Accessibility Survey

City of Downey Civic Center Drive - 3rd Street to Brookshire Avenue

Date of Inspection 8/12/2017

Disability Access Consultants

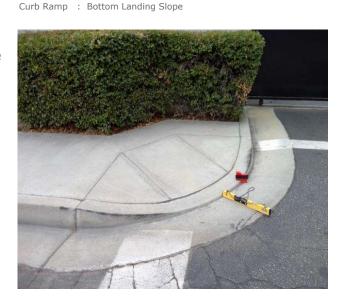
The bottom landing of the curb ramp is on the street, and the slope of the bottom landing is not compliant.

On-Site Finding 10.90 percent

Ensure the bottom landing slope is compliant and provides a smooth transition.

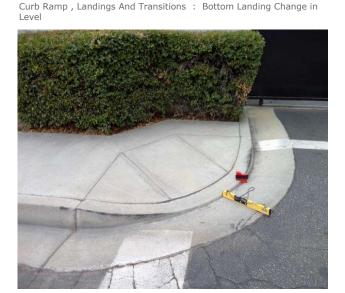
The transition from the bottom of the curb ramp to the walk, gutter, or street is abrupt.

On-Site Finding 0.87 inches

Patch the transition area at the bottom of the curb ramp so that the transition is flush and free of abrupt changes.

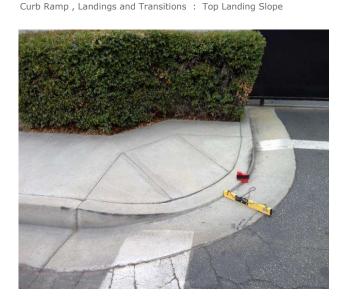
The slope at the top landing is greater than allowed.

On-Site Finding 2.80 percent

Provide a top landing surface that does not exceed the maximum slope and cross slope. Provide a sufficient maneuvering clearance that does not accumulate water.

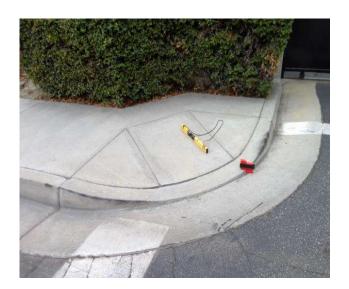
The width of the curb ramp is less than required.

On-Site Finding 36.00 inches

Provide a compliant curb ramp.

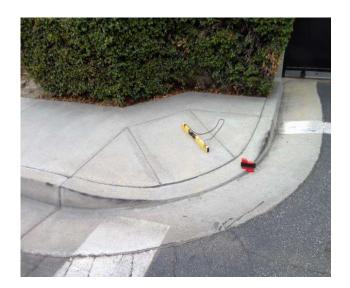
The running slope is greater than allowed.

On-Site Finding 12.90 percent

Provide a compliant curb ramp.
